PERMIT APPLICATION NO. PA2503517 RESPONSE TO REQUEST FOR FURTHER INFORMATION, AND COUNCIL COMMENTS - 695-699 LA TROBE STREET DOCKLANDS

Urbis continues to act on behalf of the permit applicant, Salta Properties (Docklands) Pty Ltd, in relation to planning permit application PA2503517 at 695-699 La Trobe Street, Docklands.

We write in response to DTP's Request for Further Information (RFI) dated 25 March 2025, the preliminary comments received, and the comments received from Melbourne City Council (including all internal referral departments at Appendix A).

Picture 3 View from Central Pier, demonstrating sufficient separation and the avoidance of a 'wall effect'

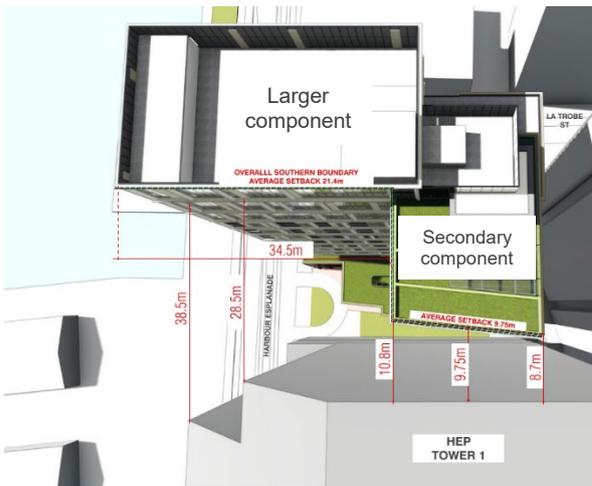
The Design and Development Overlay Schedule 52 seeks to ensure developments are appropriately spaced and avoid the creation of a wall effect. The planning context of the site has changed in recent years with the expiry of Ministerial Planning Permit PA010-006245A-2 and the approval of Amendment C438, however there is now further concern with the 'squeezing' of this proposed tower along Harbour Esplanade. At a minimum, the proposal needs to demonstrate a 10 metre tower setback from Tower 1 to avoid the creation of a wall effect and to improve the internal/ external amenity (Figure 2).

Fender Katsalidis have prepared a Tower Separation Study for the proposal, which demonstrates that the proposed separation to the south is appropriate. We have discussed this in detail above in response to DTP's RFI. In brief, we note that:

- The façade is broken into two components to the south, with the rear, recessive component closer to the proposed Tower 1 (length of approx. 22 metres), and the larger component (length of approx. 34.5 metres) substantially separated from Tower 1. The recessive component on the eastern part of the site is sufficiently set back from the west to effectively separate the towers when viewed from the harbour.
- Distinct façade treatments to the two components ensures they are clearly separated.

Windows on the boundary

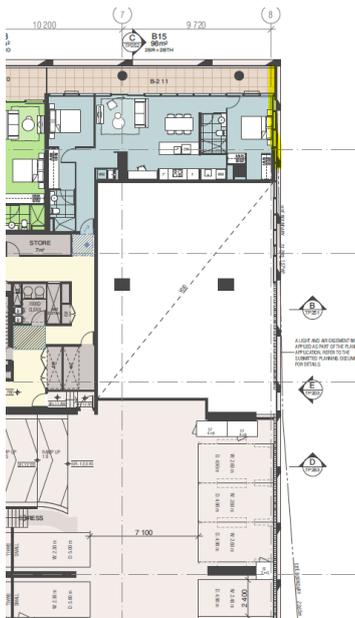
It appears that the subject land only benefits from carriageway rights over the property to the easement. The applicant must demonstrate that they benefit from a light and air right over the property to the east prior to the commencement of works.

A light and air easement is proposed over the property to the east (E-22), and will be registered on title before commencement of works.

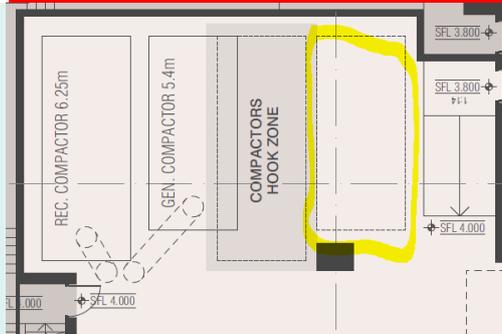
With regards to the self-driving compactors proposal: more information is required to make a full assessment of this idea.

- *Please clarify (by labelling) that the highlighted space is to be kept clear specifically for compactor manoeuvres. What is the clearance from the pillar when the smaller compactor is driven into this space?*
- *Please provide more information / specifications for the proposed compactors.*
- *Please also provide a written summary, within the WMP, of how the weekly compactor collection would work. It should be made clear that the building manager must be responsible for moving the compactors in and out of the hook lift zone. This may be needed at any time in a 24 hour period.*
- *Please provide a swept path diagram (showing the larger compactor in its collection position) that shows the clearance from the pillar.*
- *In general: the proposed arrangement using self-driving*

- The architectural plans have been amended to clarify that this space is to be kept clear at all times.
- Specification information is included within the submitted amended Waste Management Plan.
- Details of the weekly compactor collection has been included within the submitted amended Waste Management Plan. If required, further detail can be provided within the Loading Management Plan, as part of a future planning permit condition (should one issue).

- A swept path diagram has been provided showing the compactor location.
- Management of the weekly compactor collection can be included within the Loading Management Plan. We note that the compactor need only traverse a short distance of 5 metres, which will be relatively quick and ensure the compactors are ready to collect.
